MODERNIZATION AT CURRAN MIDDLE SCHOOL FOR:

MARK	DATE	DESCRIPTION
SD		
CD		
01	08/23/07	ADDENDUM 1
02	09/11/07	ADDENDUM 2
03	11/01/07	ADDENDUM 3

FLOOR DEMO PLAN BUILDINGS F, G, & H

A-123

A1 FLOOR/DEMO PLAN BUILDINGS ' F ' G ' & ' H'

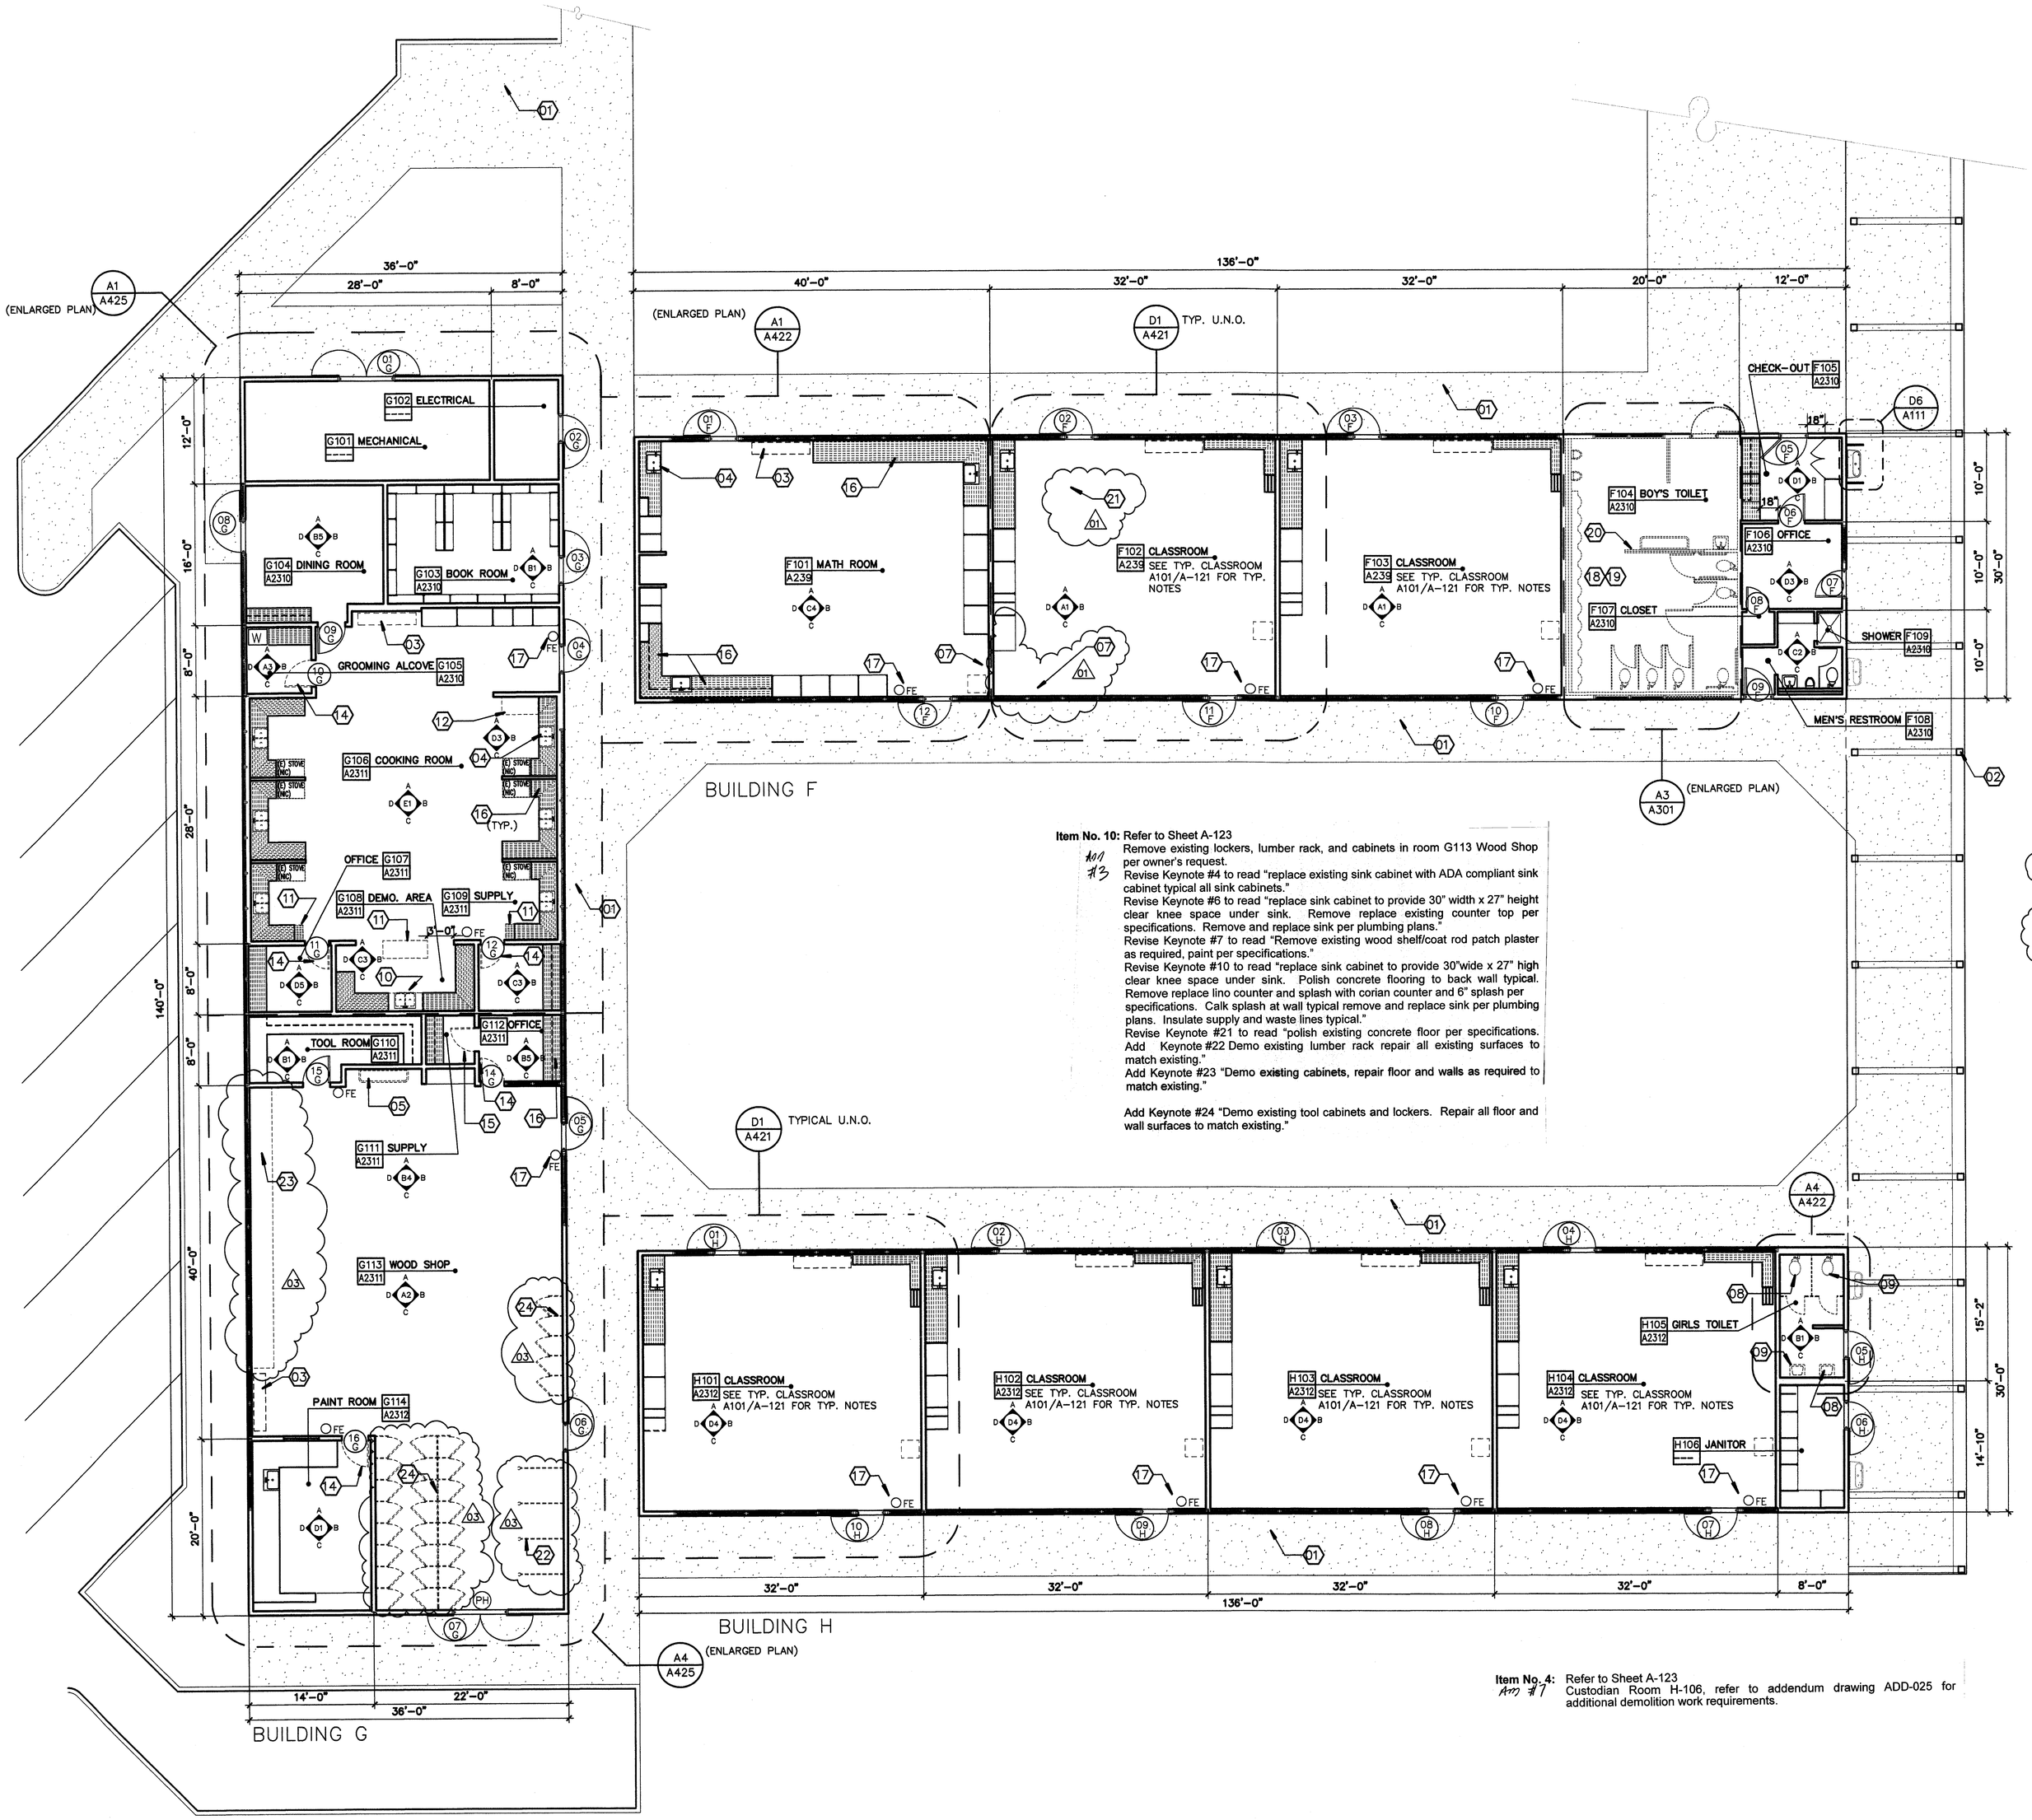
Item No. 10: Refer to Sheet A-123
Remove existing lockers, lumber rack, and cabinets in room G113 Wood Shop per owner's request.
Revise Keynote #4 to read "replace existing sink cabinet with ADA compliant sink cabinet typical all sink cabinets."
Revise Keynote #6 to read "replace sink cabinet to provide 30" width x 27" height clear knee space under sink. Remove replace existing counter top per specifications. Remove and replace sink per plumbing plans."
Revise Keynote #7 to read "Remove existing wood shelf/coat rod patch plaster as required, paint per specifications."
Revise Keynote #10 to read "replace sink cabinet to provide 30"wide x 27" high clear knee space under sink. Polish concrete flooring to back wall typical. Remove replace lino counter and splash with corian counter and 6" splash per specifications. Calk splash at wall typical remove and replace sink per plumbing plans. Insulate supply and waste lines typical."

Revise Keynote #21 to read "polish existing concrete floor per specifications. Add Keynote #22 Demo existing lumber rack repair all existing surfaces to match existing."
Add Keynote #23 "Demo existing cabinets, repair floor and walls as required to match existing."

Add Keynote #24 "Demo existing tool cabinets and lockers. Repair all floor and wall surfaces to match existing."

Item No. 4: Refer to Sheet A-123
Custodian Room H-106, refer to addendum drawing ADD-025 for additional demolition work requirements.

04 REPLACE EXISTING SINK CABINET WITH ADA COMPLIANT SINK CABINET TYPICAL ALL SINK CABINETS (03)

06 REPLACE SINK CABINET TO PROVIDE 30"W X 27"H CLEAR KNEE SPACE UNDER SINK. REMOVE/REPLACE EXISTING COUNTERTOP PER SPROFICATIONS. REMOVE/REPLACE SINK-SEE PLUMBING DWGS.

21 POLISHED CONCRETE FLOOR PER SPECIFICATIONS (03)

22 DEMO EXISTING LUMBER RACK, PREPARE ALL SURFACES TO MATCH EXISTING TYP. (03)

23 DEMO EXISTING CABINETS PREPARE FLOOR AND WALL SURFACES AS REQUIRED TO MATCH EXISTING TYP.

24 DEMO EXISTING TOOL CABINETS AND LOCKERS, PREPARE ALL FLOOR AND WALL SURFACES TO MATCH EXISTING TYP.
